Addendum No. 1

Project: Village on the Preserve – Phase 2
For: Lanoha Development

Date: 1 February 2012
 From: Studio 951, Ltd.
 To: All plan holders.

A4.01-1

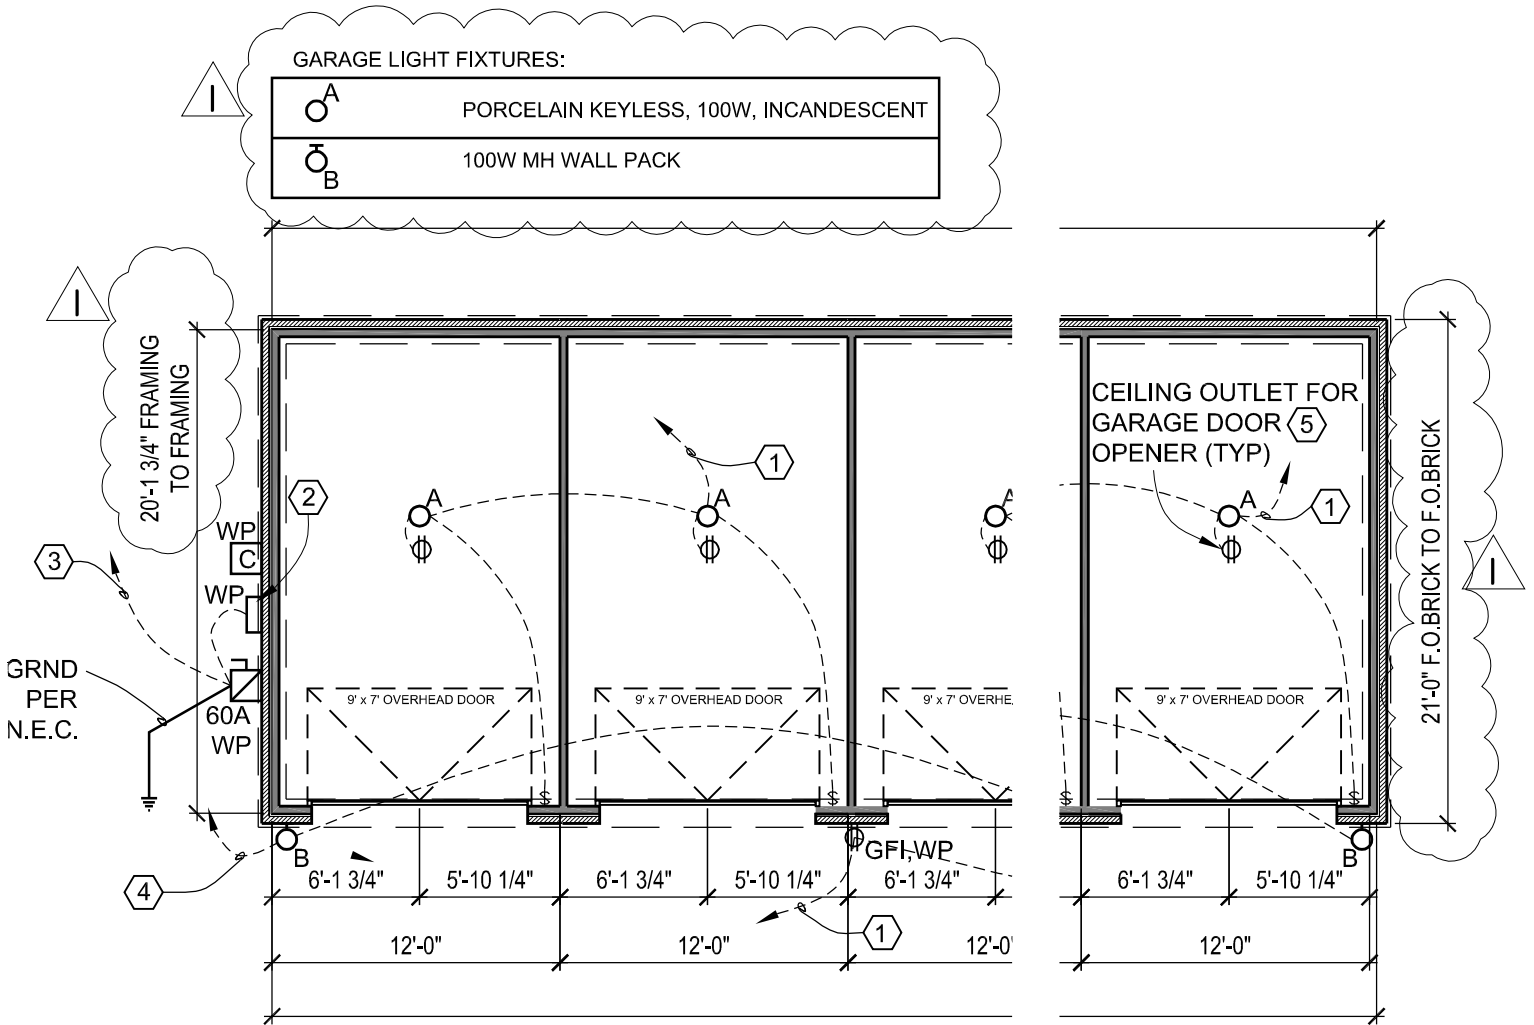
See A4.01-1 showing revised dimensions for depth of detached garage units. Notes added for light fixtures.

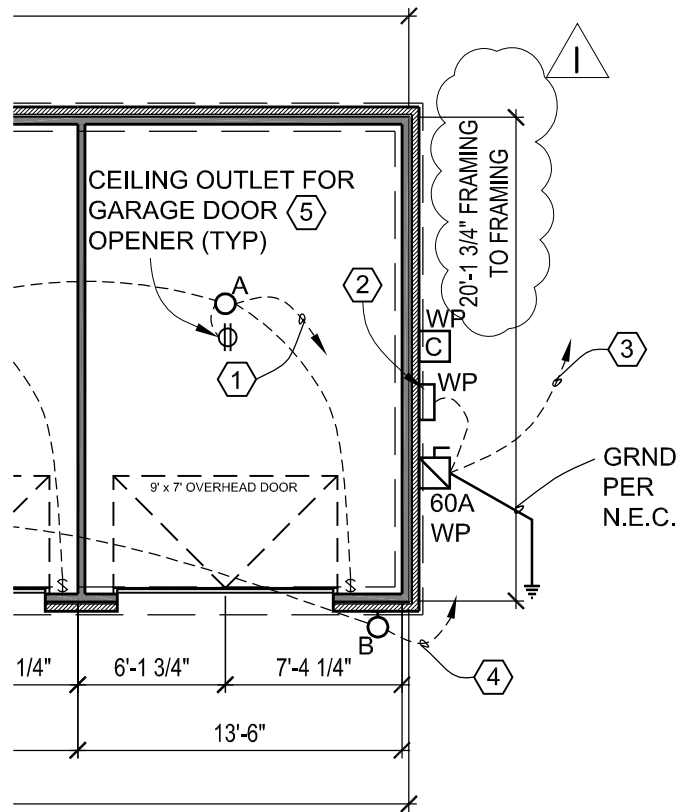
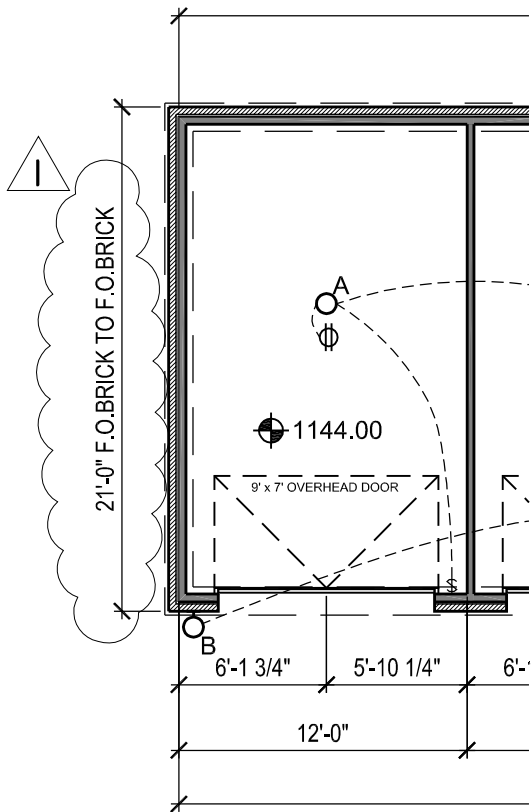
See A4.02-1 showing revised dimensions for depth of detached garage units. Notes added for light fixtures.

S2.4

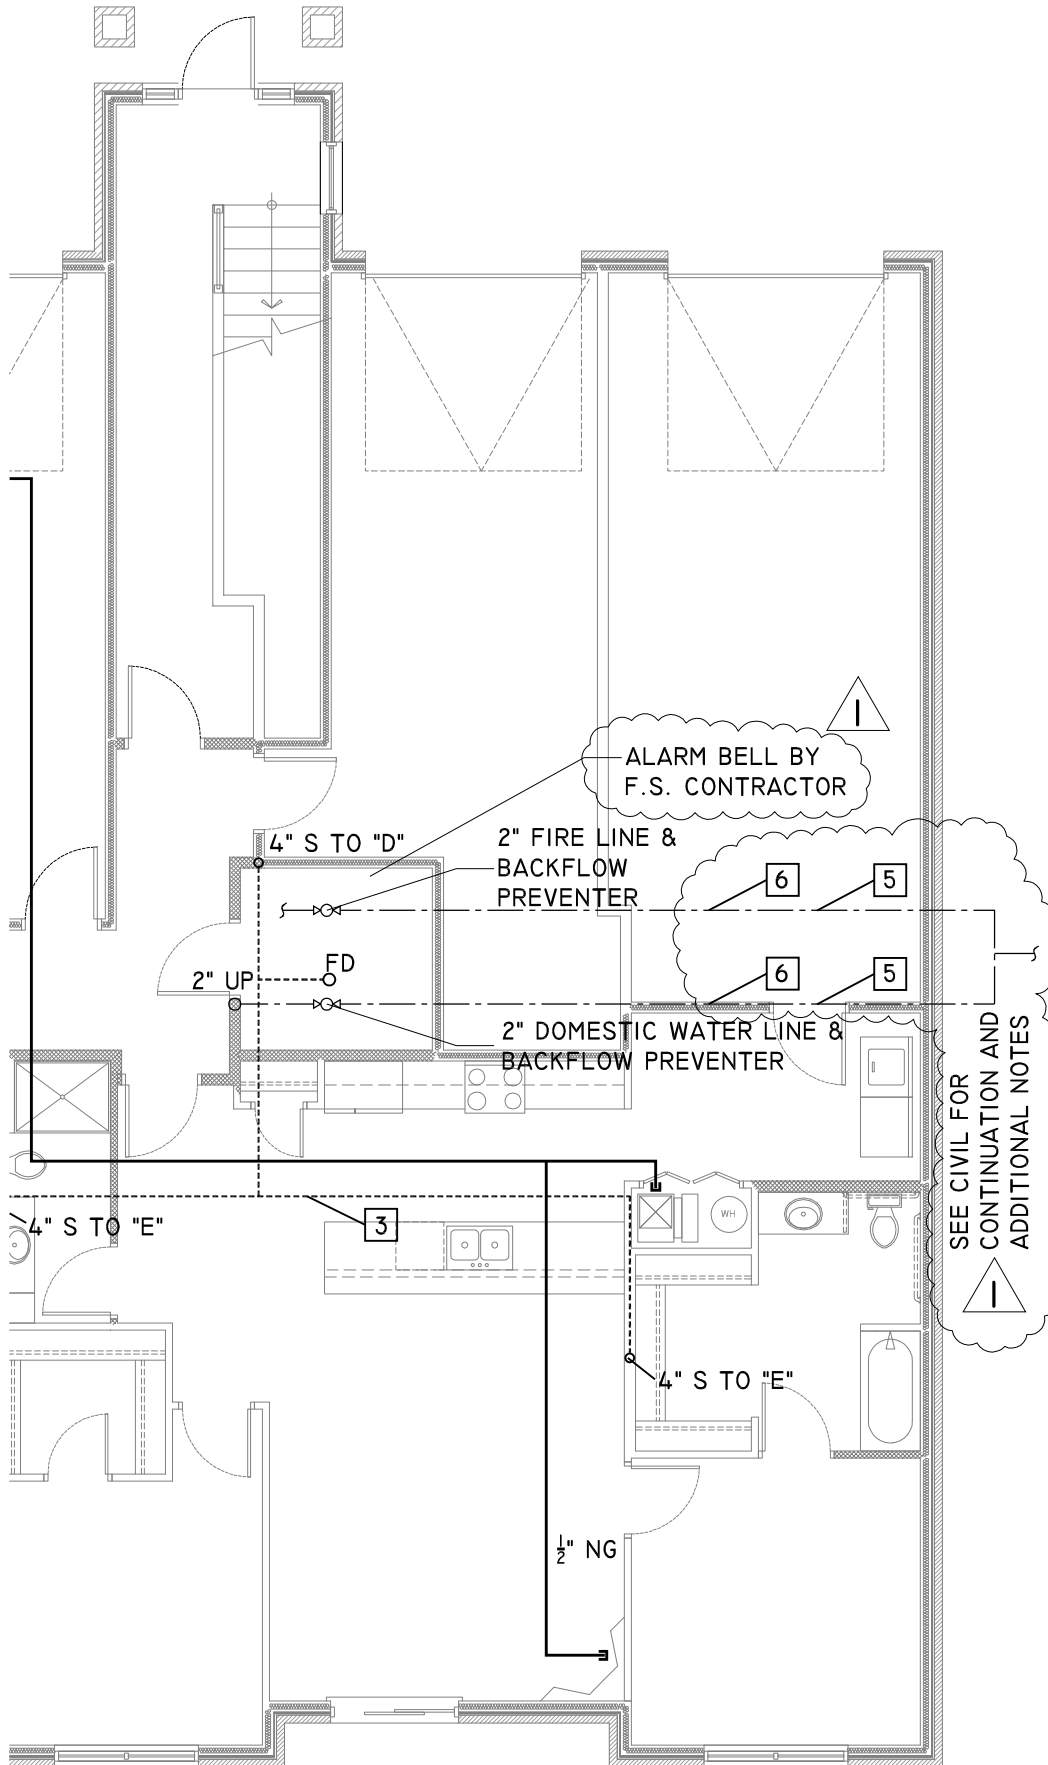
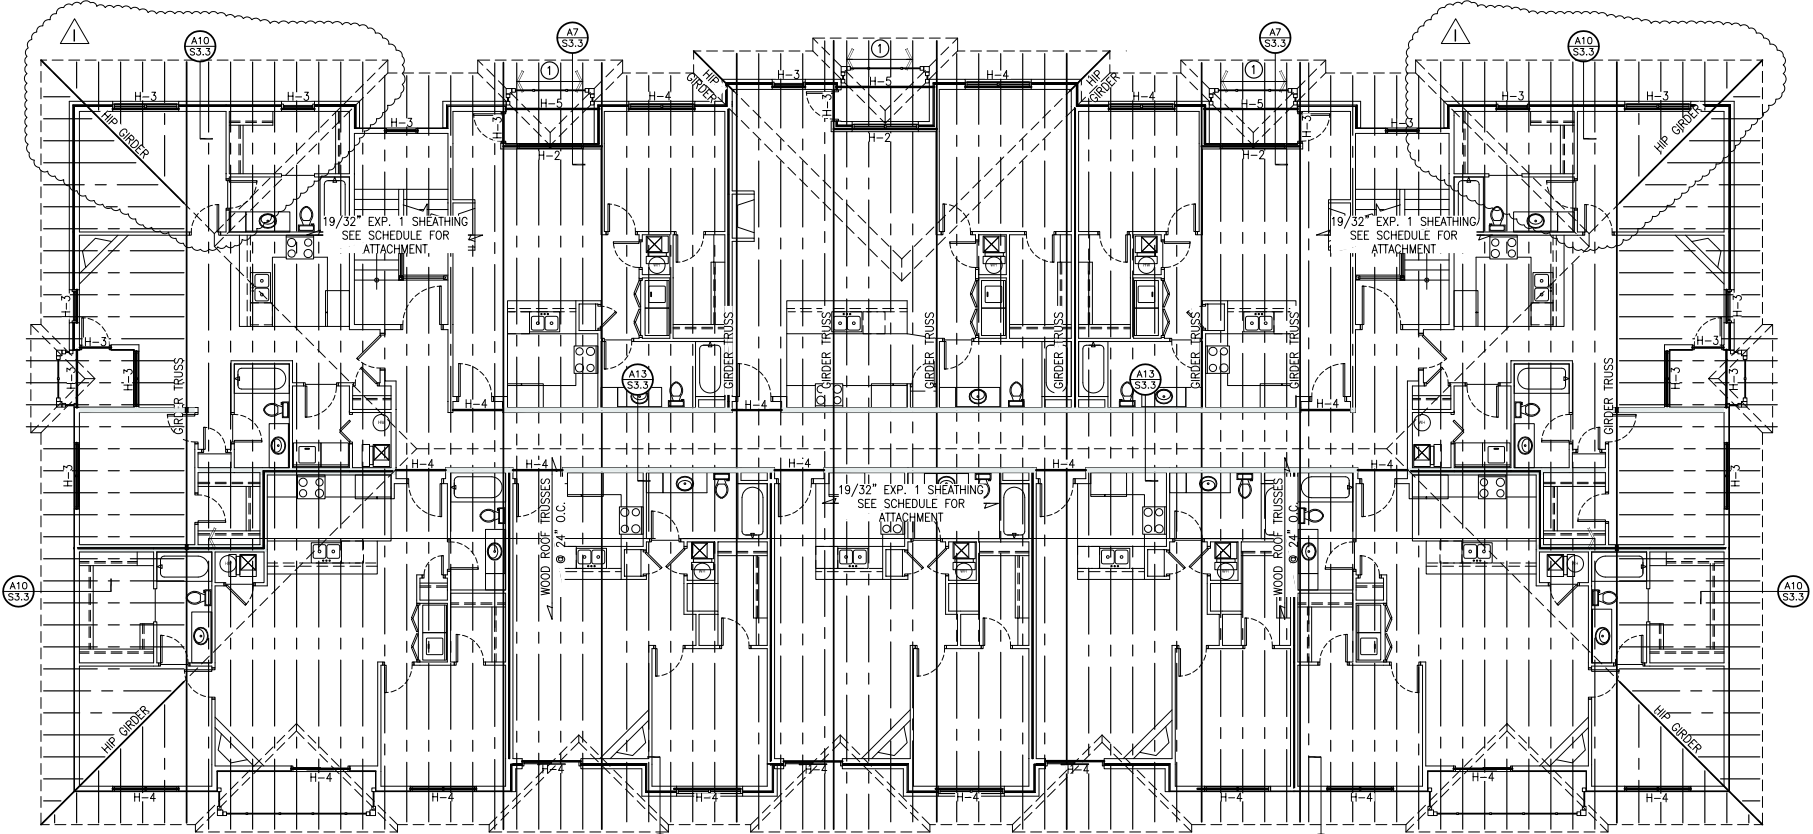
S2.4 – See revised roof plan attached. The attached plan is printed not to scale at 11"x17" from a 36"x24" original.

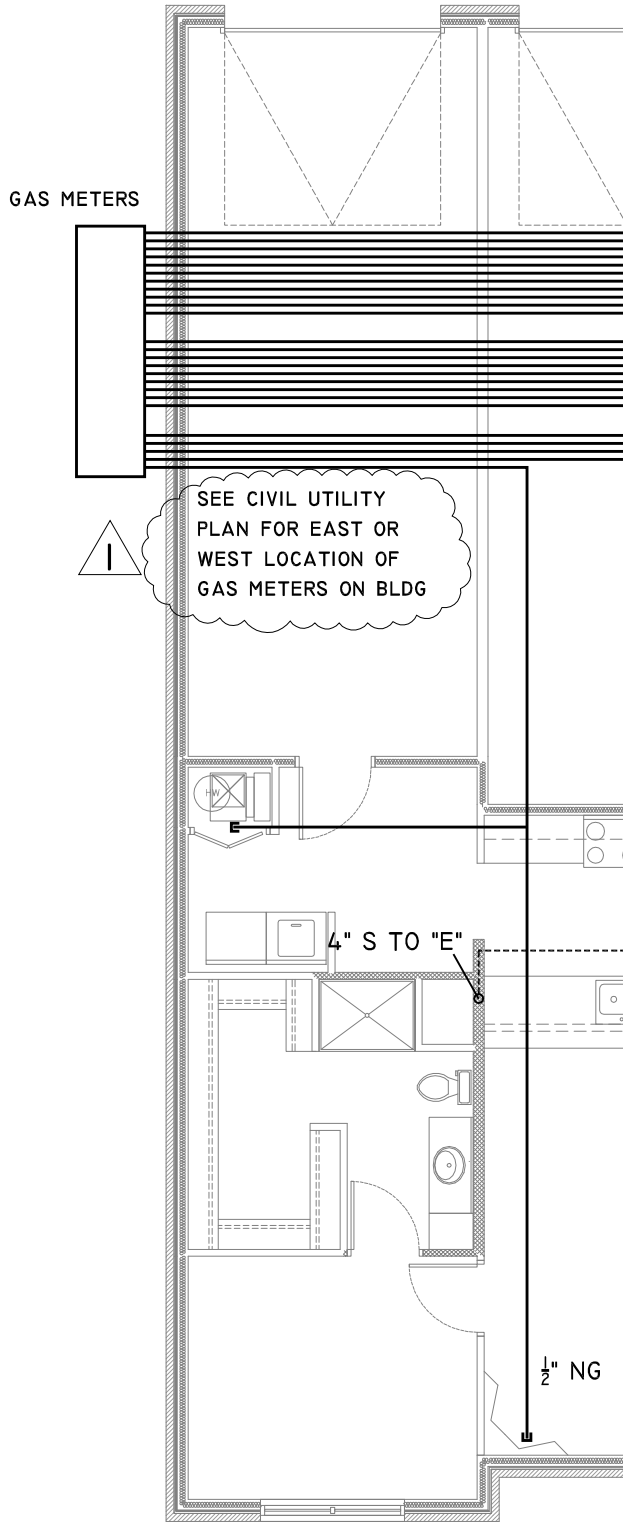
See P2.01-1, P2.01-2 for revised Main Floor Overall Plumbing Plan showing coordination with the revised information on C4.0 noted above.

E2.01-1

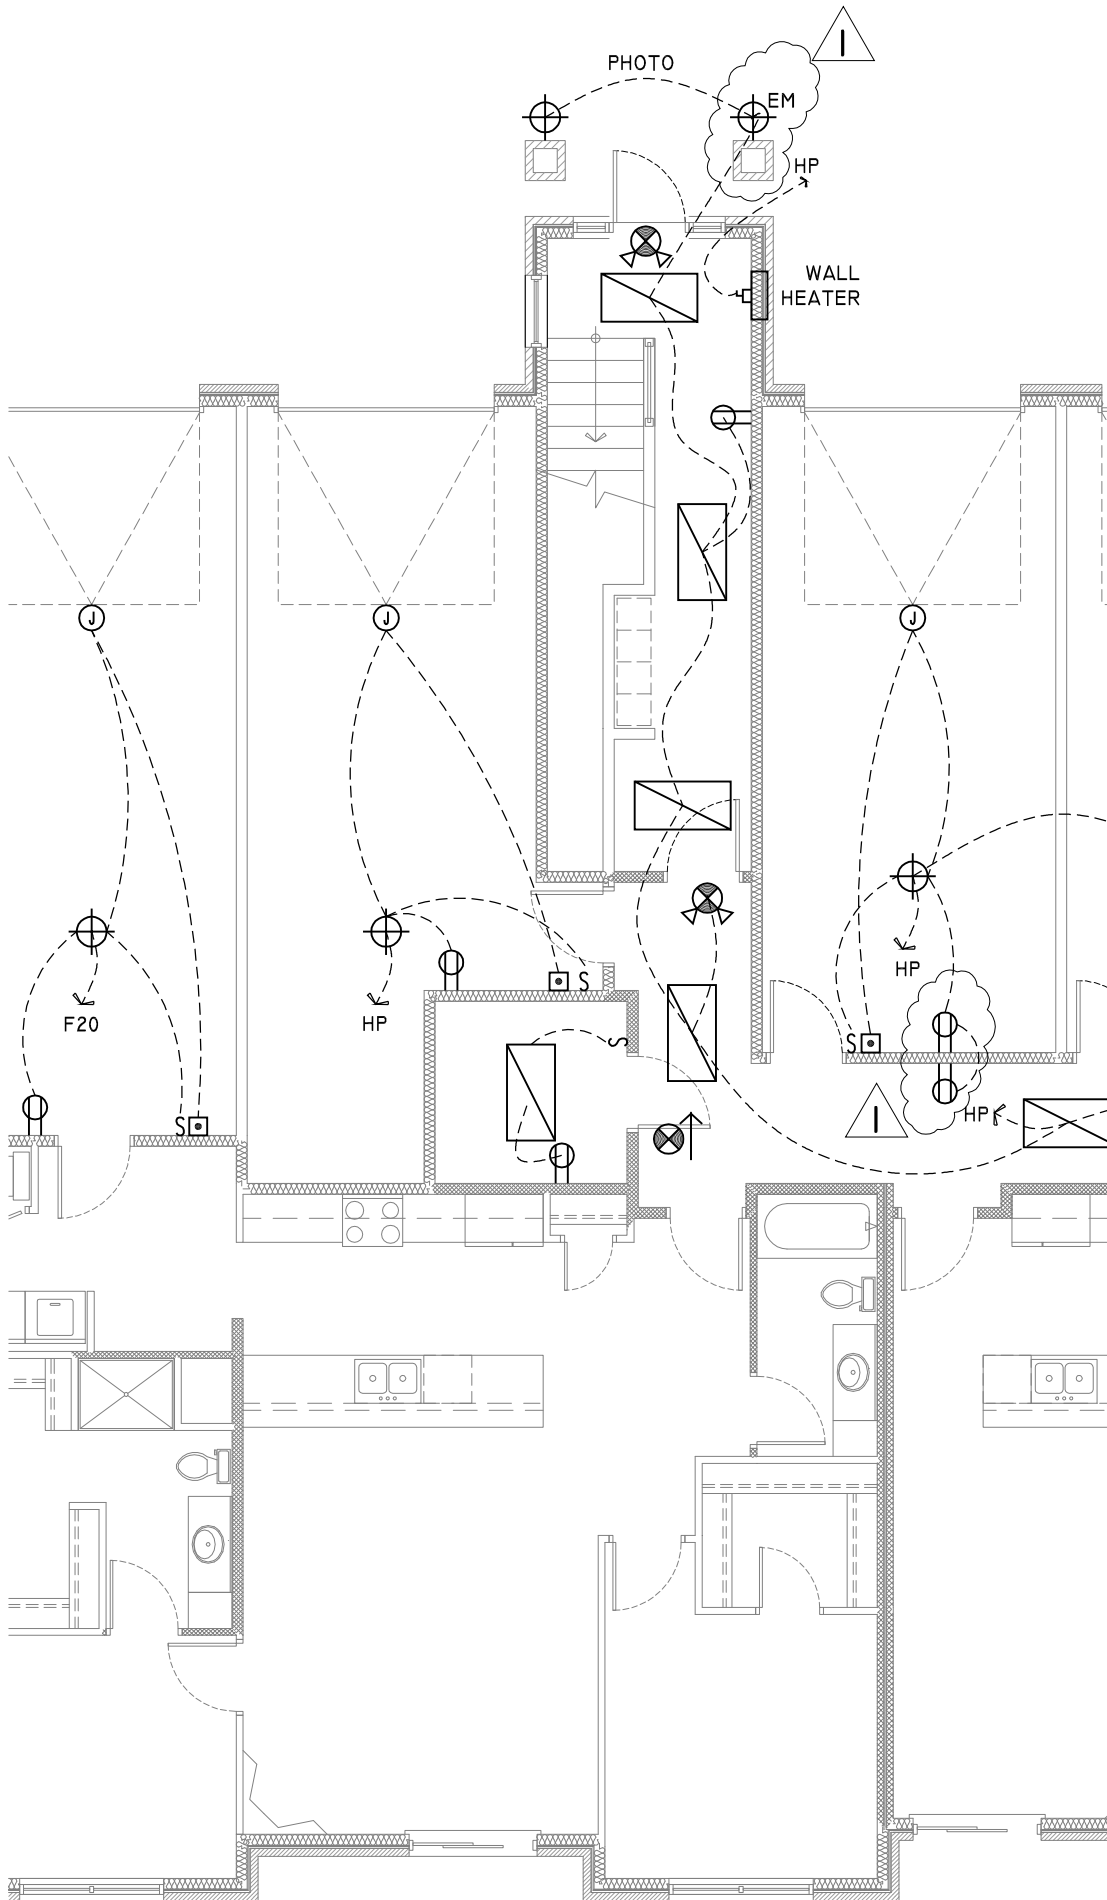
See E2.01-1 showing revisions to the Electrical Riser.

E2.01-2

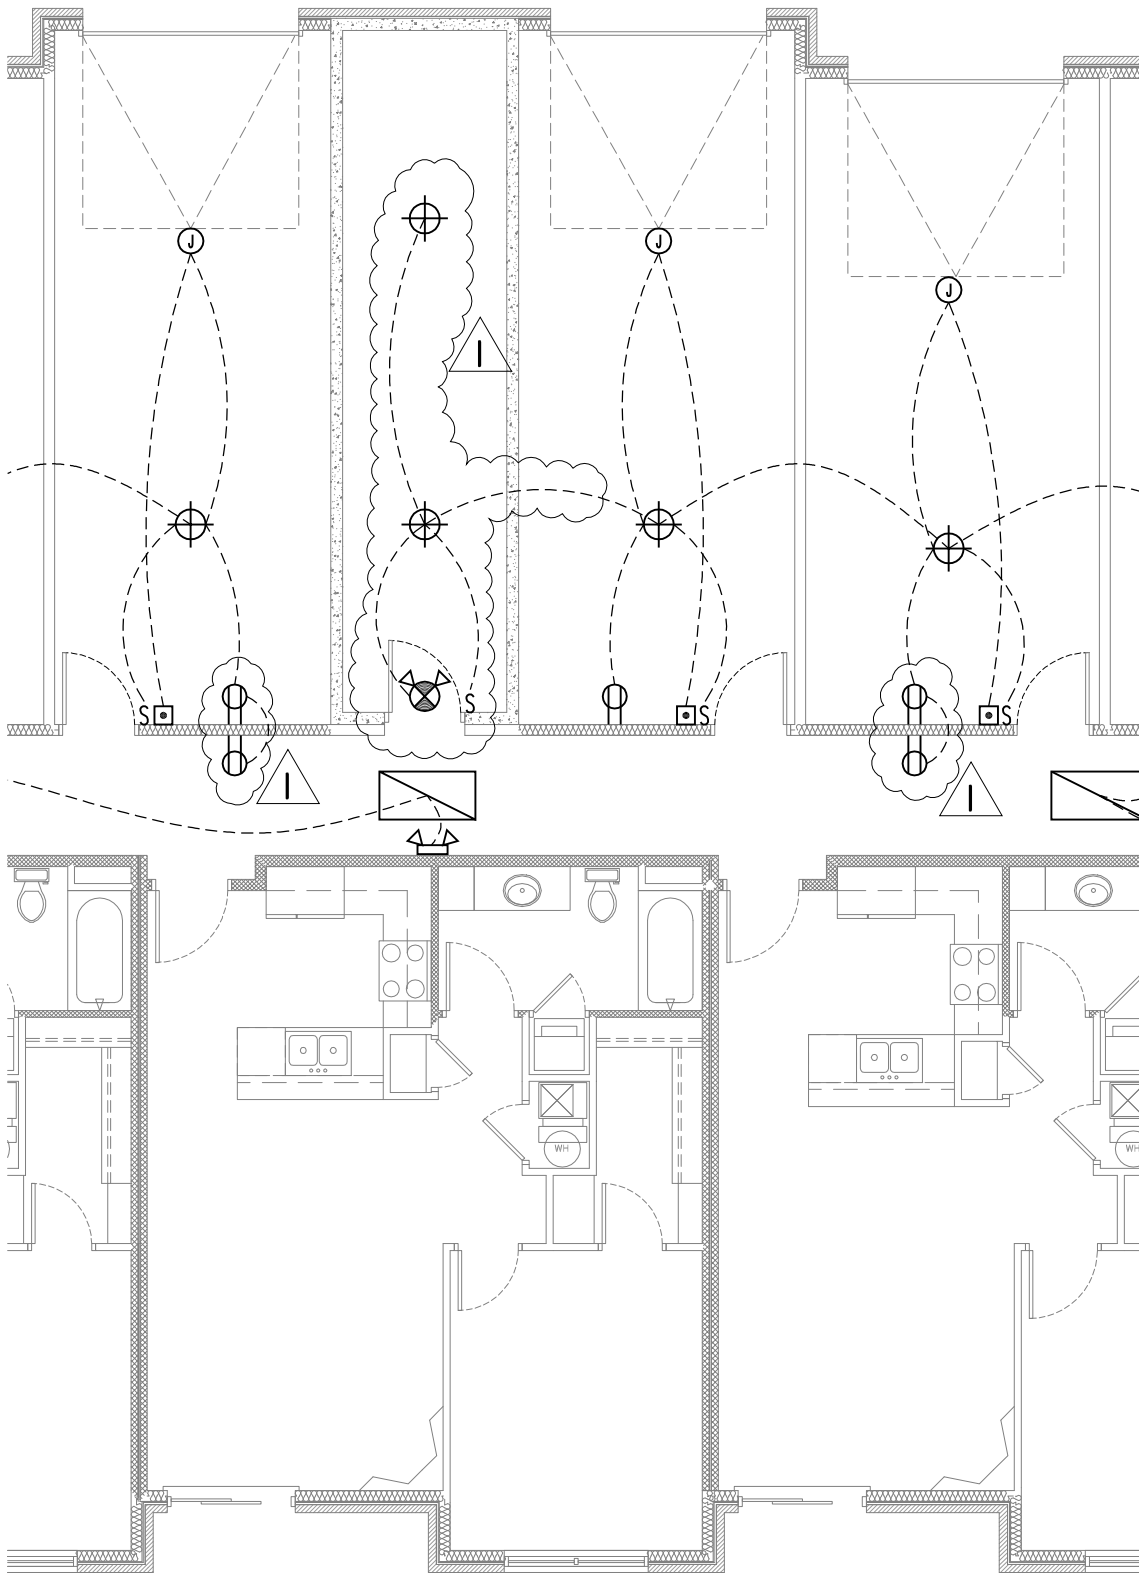
See E2.01-2, E2.01-3, E2.01-4 showing revision to the Main Floor Electrical Plan.
